The 55 details drawn differently in CAD and Revit

Checked against the new drafters' file, 26 October.

55 of the 190 CAD typical details have a Revit version in your templates that is drawn differently. Each page: your CAD detail on the left, the Revit version on the right, what differs, and one answer: CAD is right, Revit is newer (we update CAD from it), or both wrong.

CAD: KOR-D502-DET 28 - TYPICAL COLUMN CAPITAL

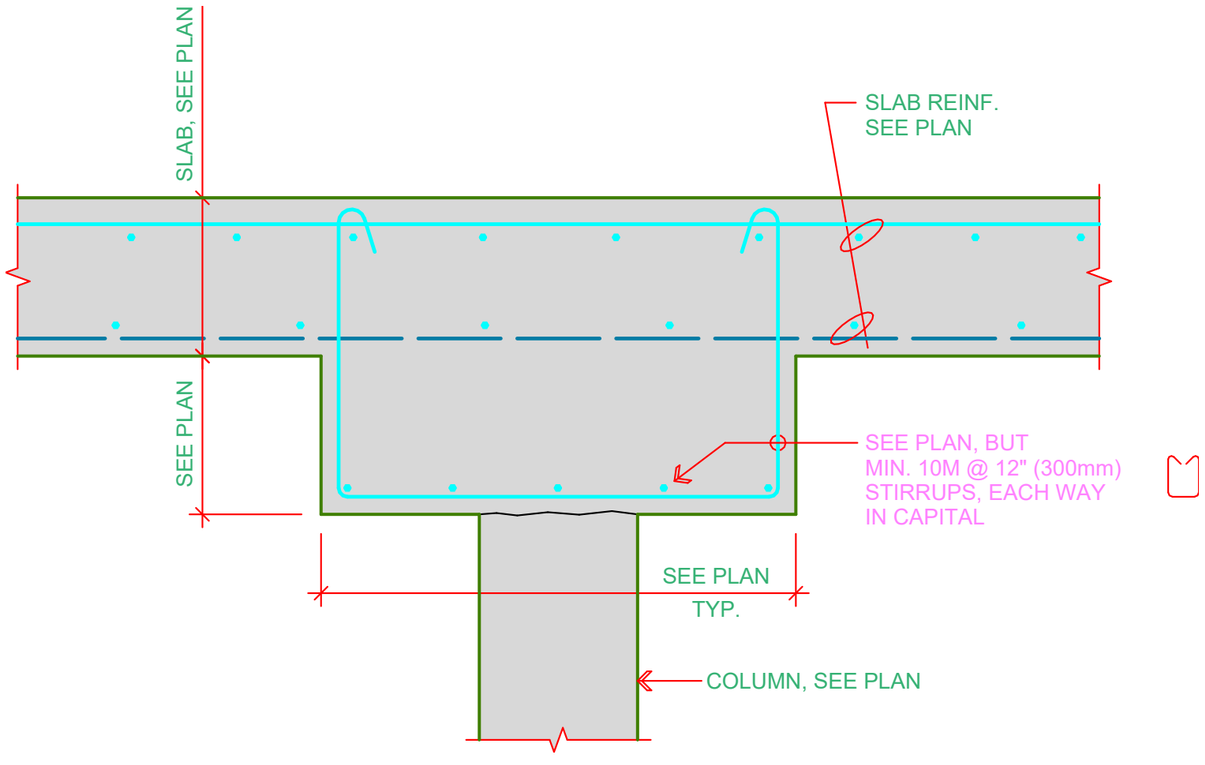
What differs: Column capital but CAD capital is wider with a different bar arrangement and no hooked top bars.

Revit: 1E1.05_14_TYPICAL ARCHITECTURAL SITE WALL (Kor_Concrete_Tower_Project_Template_Arch D E1 E_R24 (Do Not ; on 1E1.05 TYPICAL DETAILS)

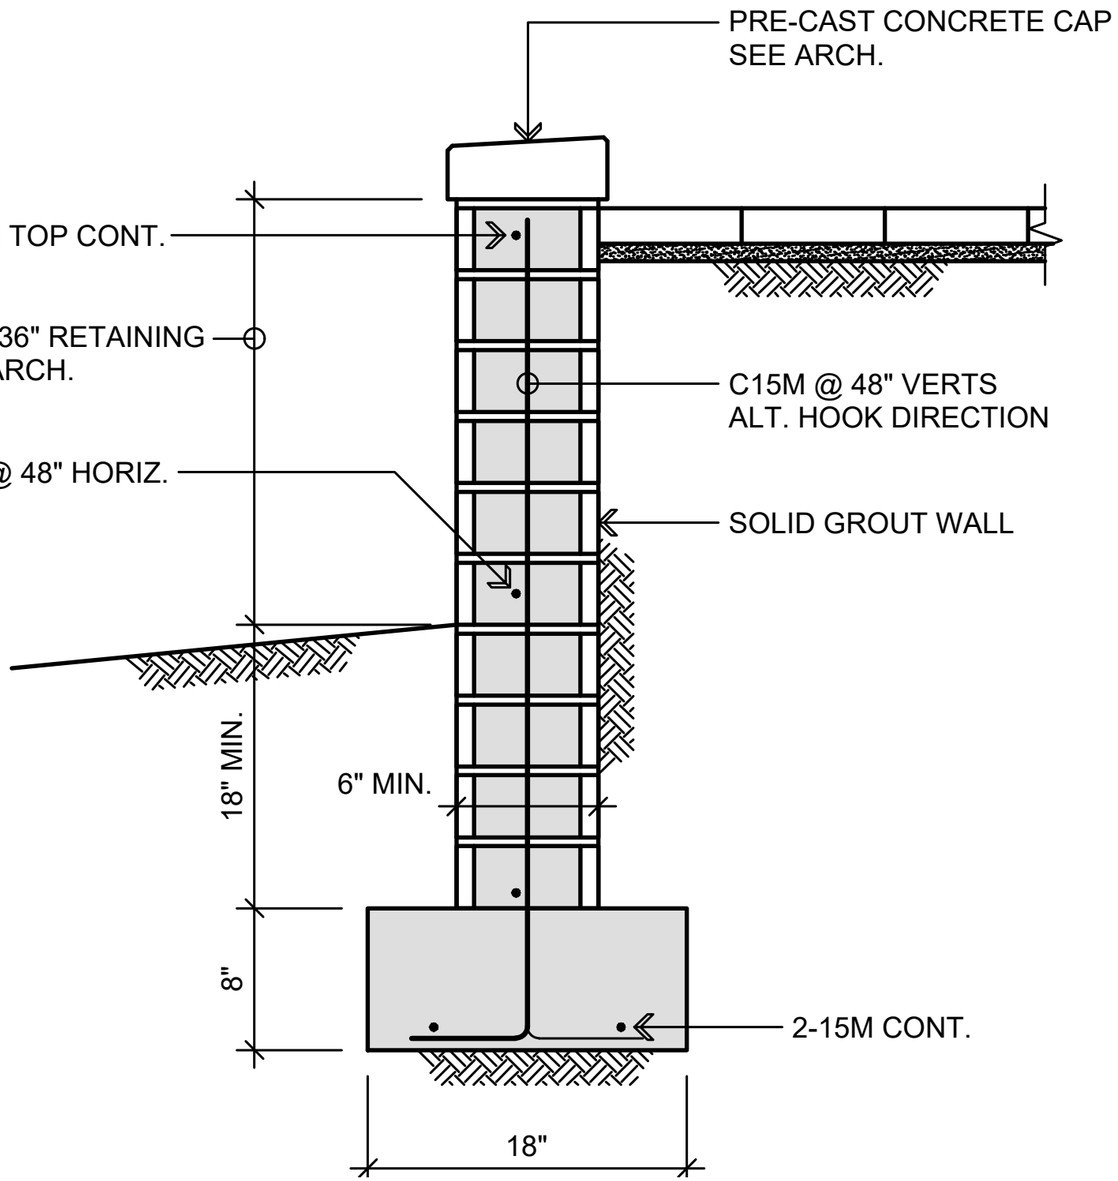
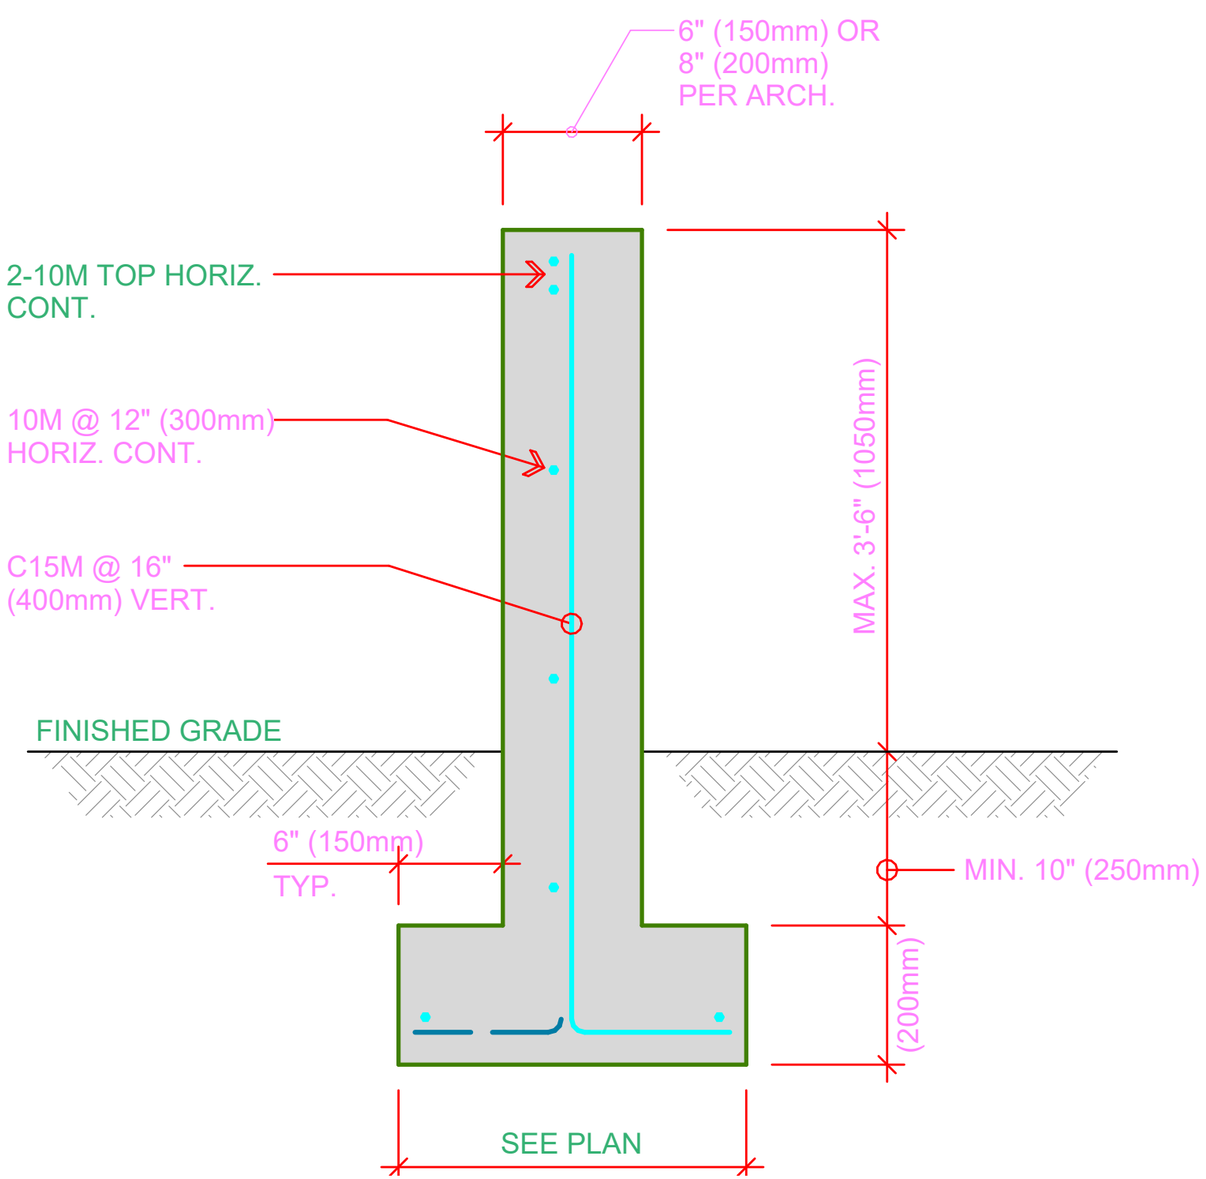
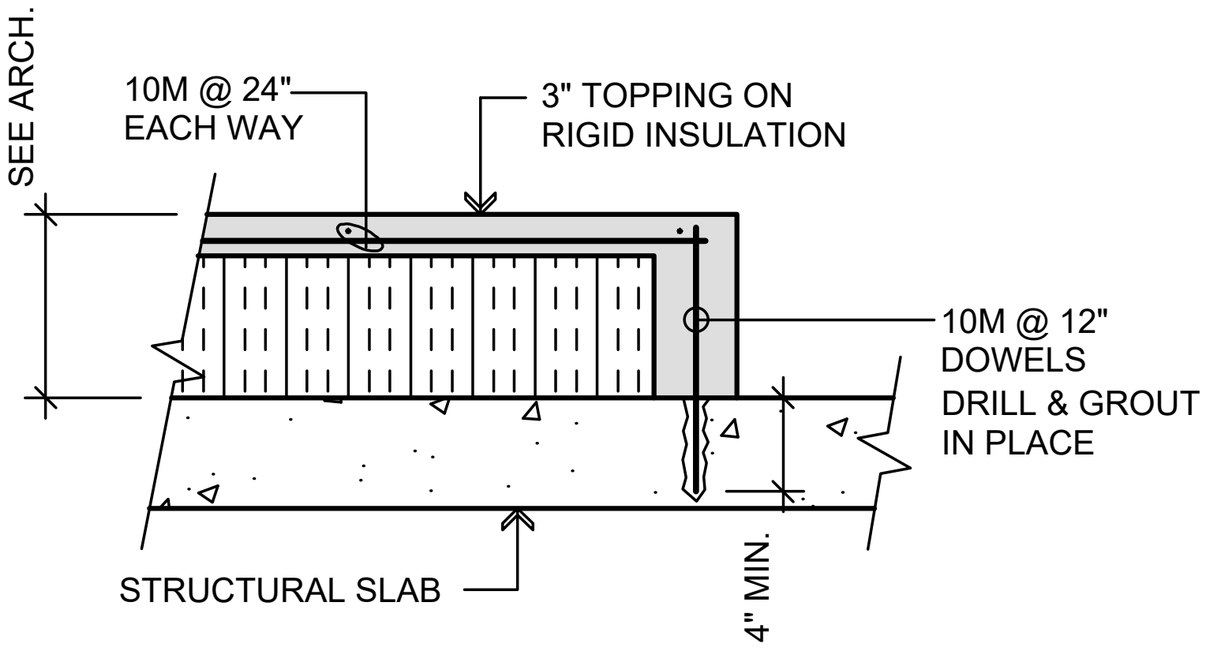
What differs: Both low site walls on footings, but CAD is a grouted masonry retaining wall with precast cap, Revit a concrete wall.

CAD: KOR-D502-DET 34 - BUILT-UP SLAB DETAIL

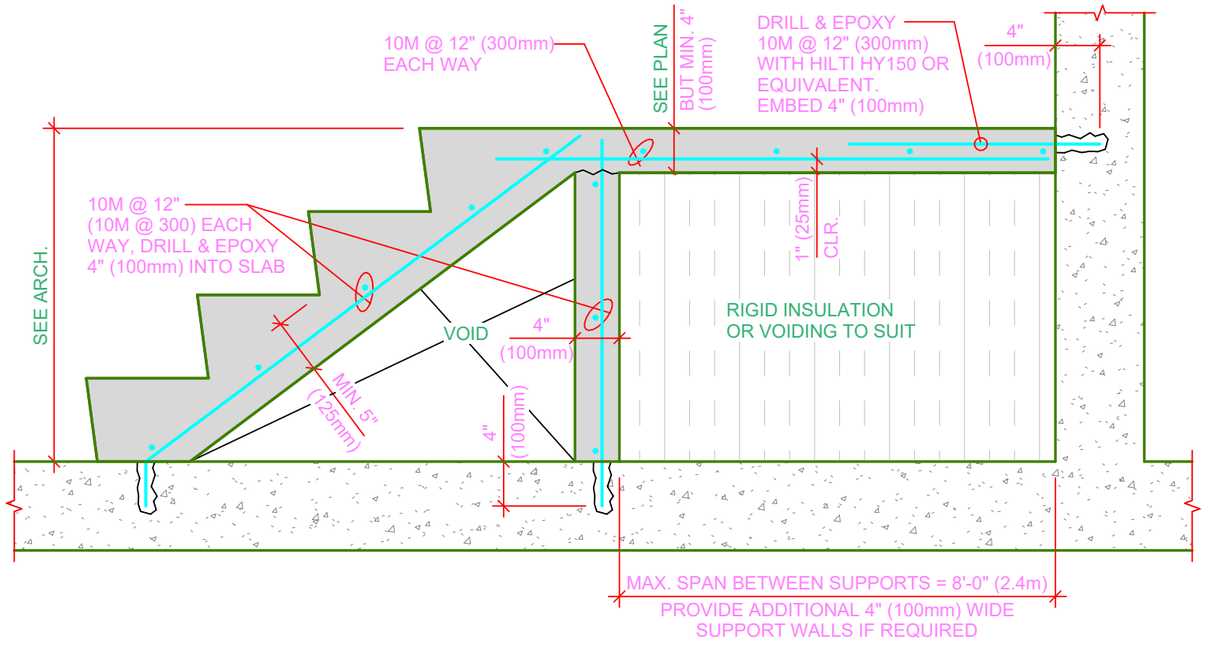
What differs: Both built-up slabs with rigid insulation, but CAD is topping on insulation with dowels, Revit a stepped fill with support walls.

Revit: D5.02_7_SANDWICH SLAB DETAIL (Typical Details - Container_R23 (Need_MET & IMP).rvt; on D5.02 Series 5 Miscellan)

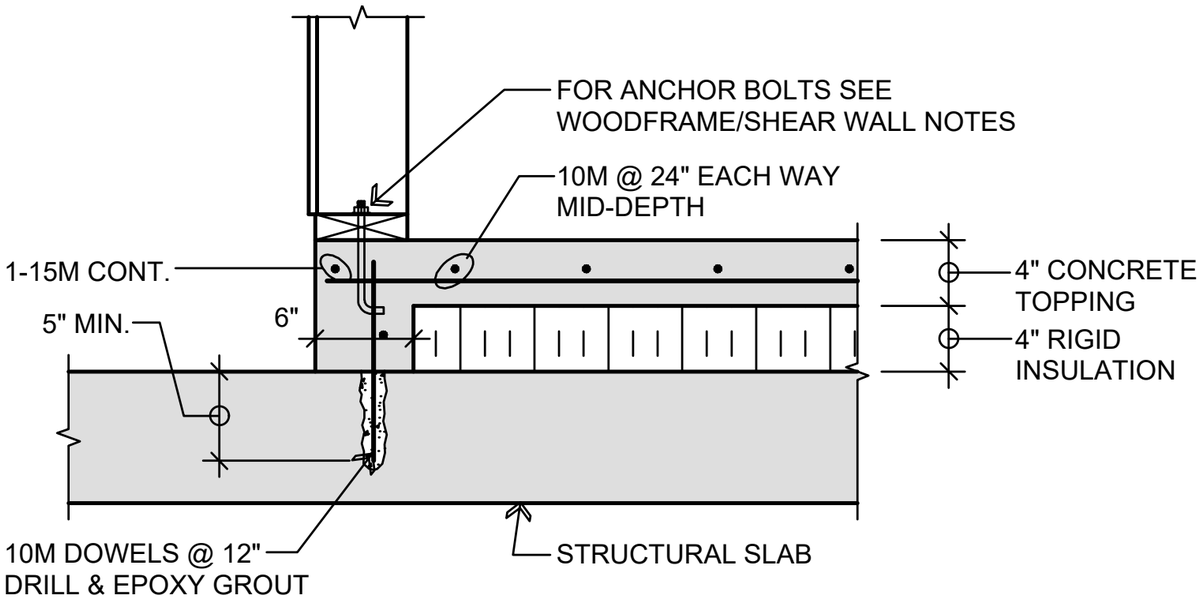
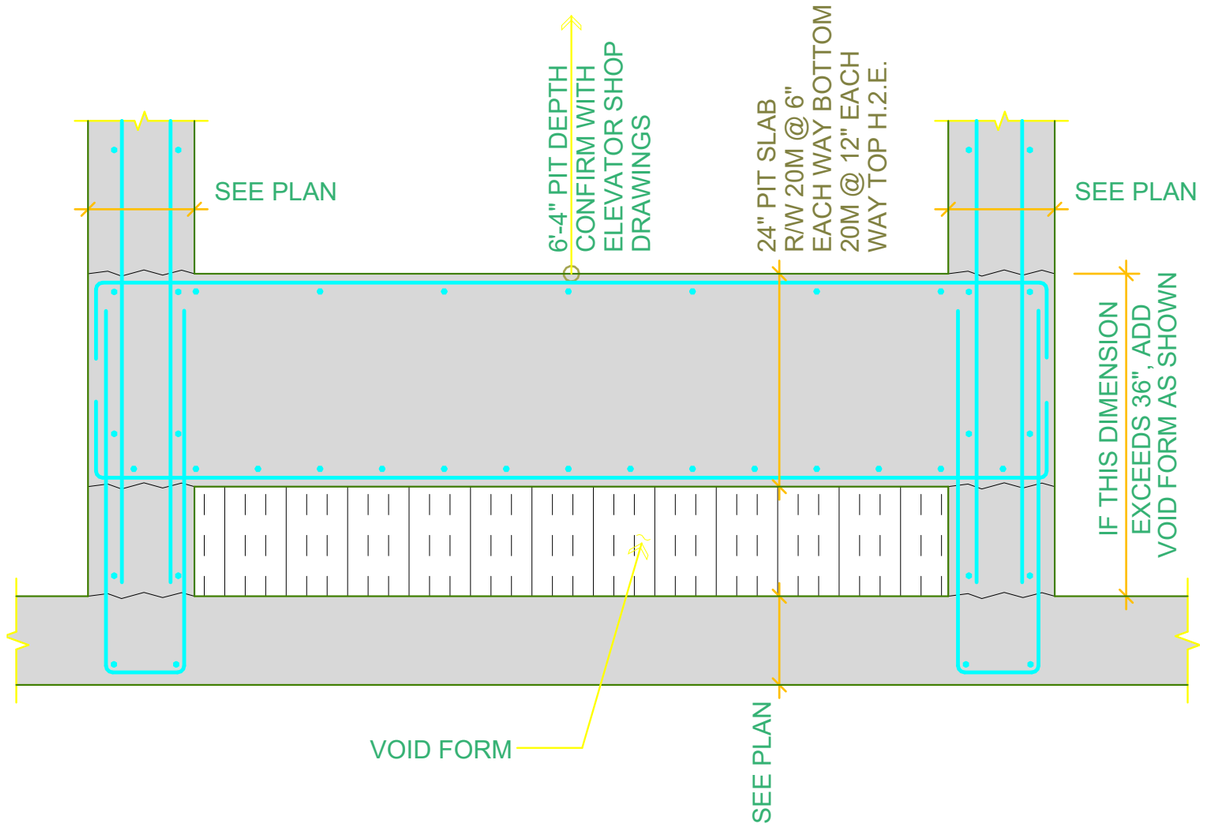
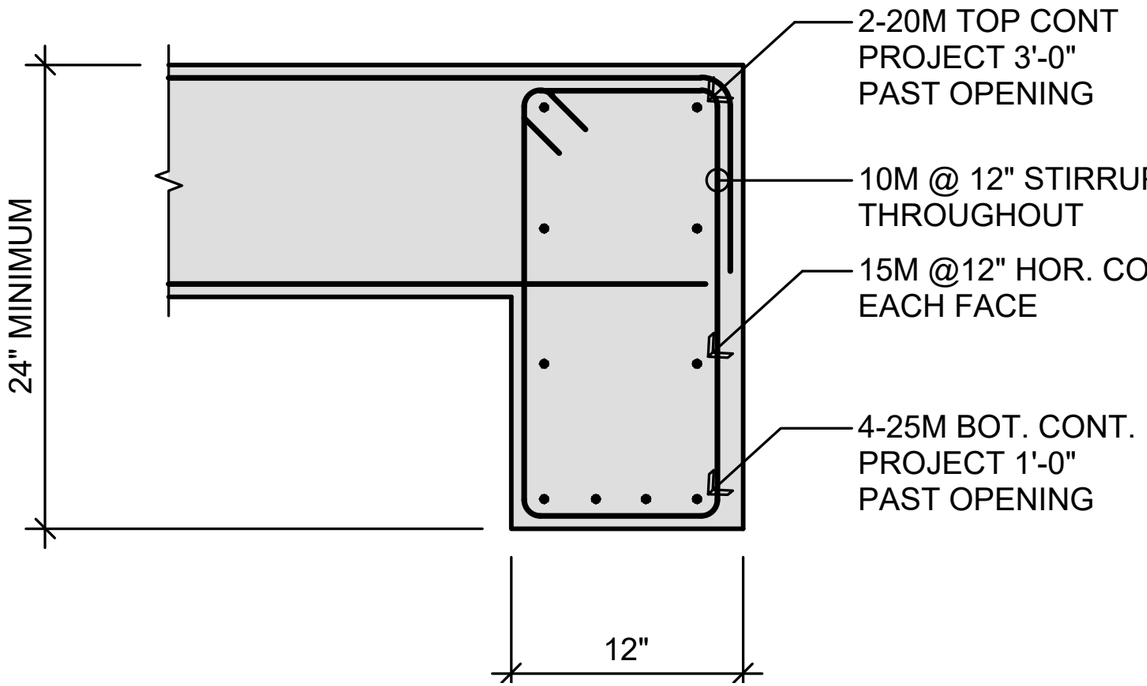
What differs: Same title, but CAD is topping on rigid insulation over structural slab, Revit a slab over void form at a pit.

CAD: KOR-D504-DET 06 - DOWNTURN DETAIL

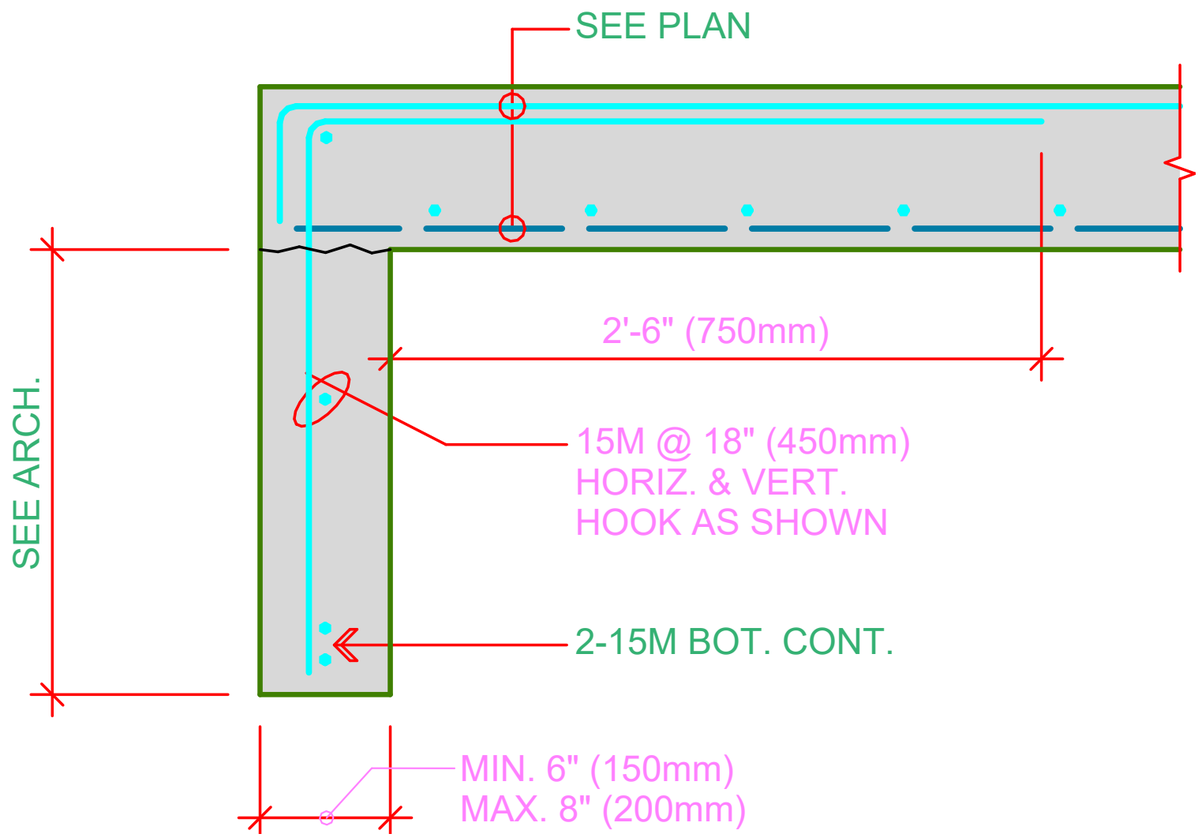
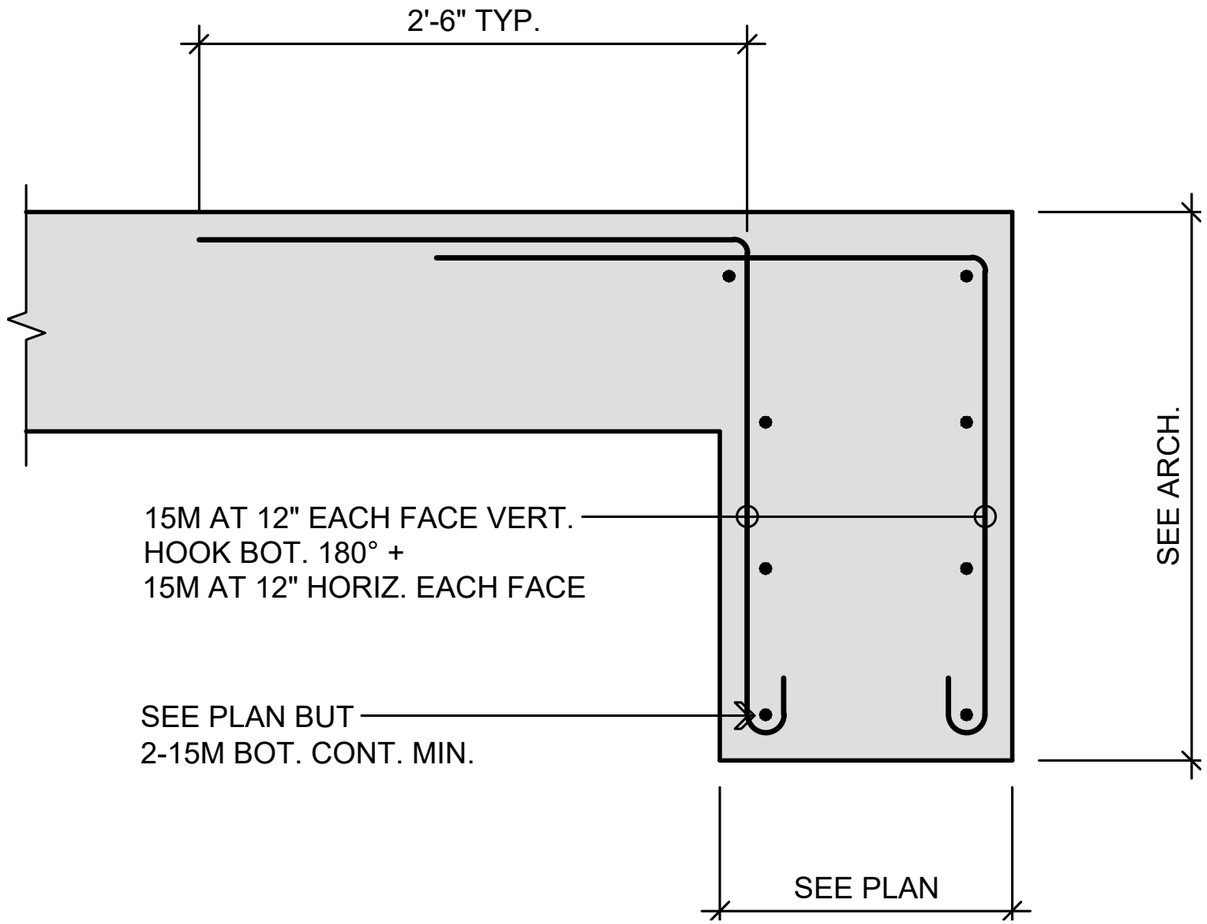
What differs: CAD is a 24in-min downturn beam with stirrups, 2-20M top and 4-25M bot projecting past an opening; '1E1.04_13_TYPICAL DOWNTURN' is a thin 6-8in downturn wall with 15M @ 18in.
